Response to Request for Advice – 104-116 Regent Street, Redfern – Student Accommodation (SSD-12618001)

This letter has been written in response to the Request for Advice Letter dated 2 March 2022 from the City of Sydney (SSD-12618001).

Table 1 Response to Request for Advice

Figure 2 Ground Floor new design – Active Frontage

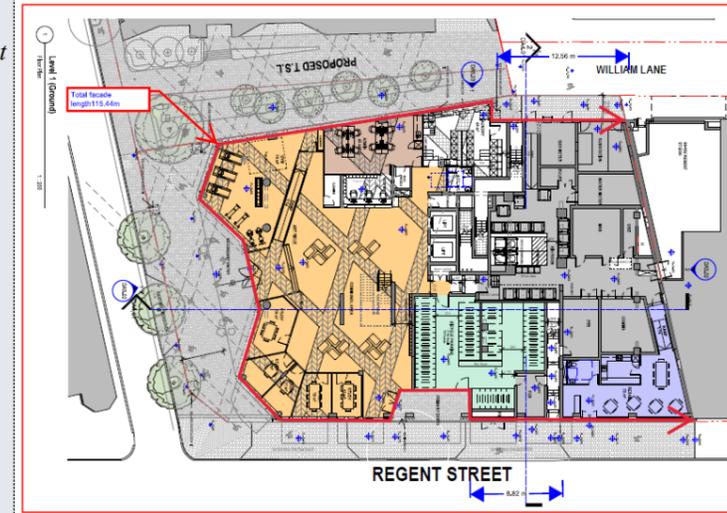
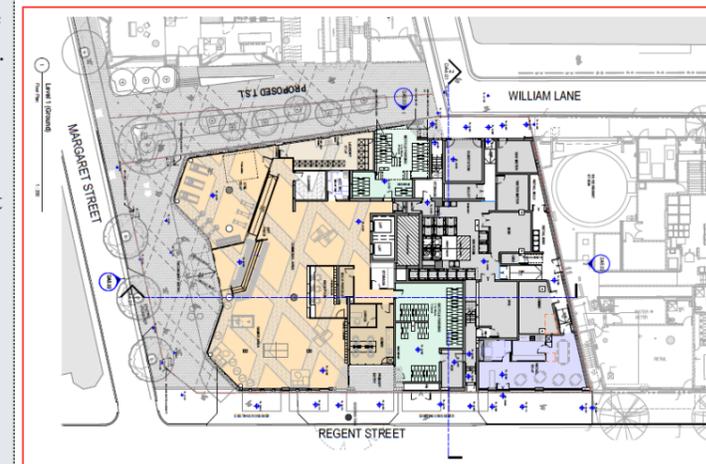
City of Sydney Matter	Design Amendments	Response
<p>e. Active Frontages</p> <p>The proposed development has frontages to Regent and Margaret Streets as well as the future through site link and provides opportunities for street activation. However, the development does not provide a genuine active frontage with good levels of passive surveillance.</p>	<p>Figure 1 and Figure 2 are used to make a comparison to show how the ground level floor plan has been redesigned to address the City of Sydney’s comments.</p> <p>The usage of the area on the corner of Regent Street and Margaret Street has been changed from study rooms to an open plan games area that will greatly increase usage of the space providing further active frontage to the street and increased passive surveillance.</p> <p>Adjacent to the entrance on Regent Street the façade has been redesigned to removal any areas of possible concealment or entrapment.</p> <p>Bicycle parking has been split and additional area is being utilized as office space facing the street to improved street activation.</p>	<p>WSP do not agree with this sentiment from Council. According to the Sydney Development Control Plan 2012:</p> <p>Active Frontage means street frontages where there is an active visual engagement between those in the street and those on the ground floors of buildings. Frequent building entries that face and open towards the street, transparent street frontages, quality materials and refined details, and mixed land uses will make streets more diverse and attractive for pedestrians and increase the perception of safety and encourage higher levels of pedestrian activity.</p> <p>There is a total of 115.44m of building and street frontage, of which vast majority of is activated through retail space (mixed land uses), glass, natural surveillance and building entries.</p> <p>This allows for the ground floor of the development to provide active visual engagement between street pedestrians and those within the building. The proposal provides building entries along Regent Street and Margaret Street activating these frontages with high pedestrian activity. Where appropriate transparent street frontages have been provided with high quality materials and details provided, this allows the pedestrians and occupants to see in and out of the building providing a high level of activation.</p> <p>A retail/café space has been provided along the Regent Street greatly activating the streetscape for pedestrians and their safety and greatly reducing any CPTED issues. Further lighting and well-placed CCTV, and clear be considered at the detailed design stages mitigating any safety concerns.</p> <p>It is therefore considered that that proposal is provides a genuine active frontage with good levels of passive surveillance. See Figure 2 which illustrates the amount of activated frontage provided by the proposal.</p>

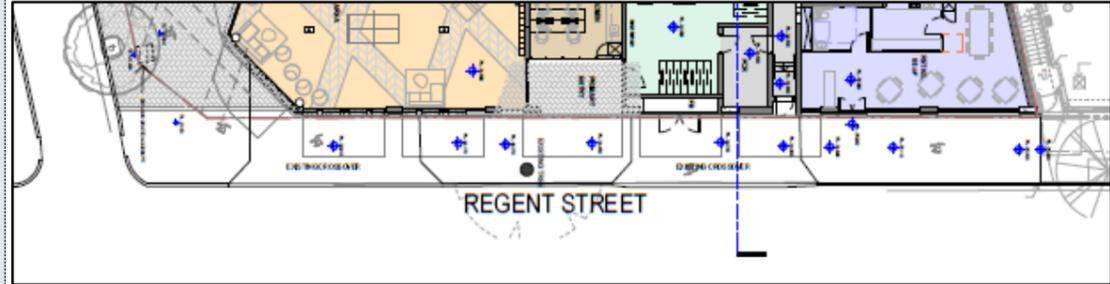
City of Sydney Matter	Design Amendments	Response	
<p>“The Regent Street entry provides minimal passive surveillance as a result of the location of the bicycle parking facilities that occupy the majority of frontage. It presents areas of concealment with Crime Prevention Through Environmental Design (CPTED) concerns for both residents and the public.”</p>	<p>Adjacent to the entrance on Regent Street the façade has been redesigned to removal any areas of possible concealment or entrapment.</p> <p>Bicycle parking has been split and additional area is being utilized as office space facing the street to improved street activation.</p>	<p>The bicycle parking does not represent a majority (more than 50%) of the street frontage and has been split and reconfigured, it constitutes less than 10 metres of the regent Street Frontage which is less than the perceived “majority”, see Figure 3.</p> <p>The Regent Street entry provides direct passive surveillance and sight lines into and out of the building onto Regent Street as outlined within Figure 4. The areas within the building are highly activated with the addition open plan games room and will maintain and increase passive surveillance. As an entry space this area will be used by residents greatly activating this space.</p> <p>The entry area and bicycle parking area will be well lit, includes a skylight, uses clear materials, and will include CCTV at the detailed design stages this will allow the Entry Space to be free for opportunities for concealment for members of the public utilising Regent Street.</p> <p>The Regent Street entry provides natural surveillance and direct sight lines into and out of the building into Regent Street in accordance with the CPTED Principles for Natural Surveillance.</p>	<p><i>Figure 3</i> Regent Street Frontage</p>  <p><i>Source: Antoniadis Architects</i></p> <p><i>Figure 4</i> Regent Street Frontage</p>  <p><i>Source: Antoniadis Architects</i></p>
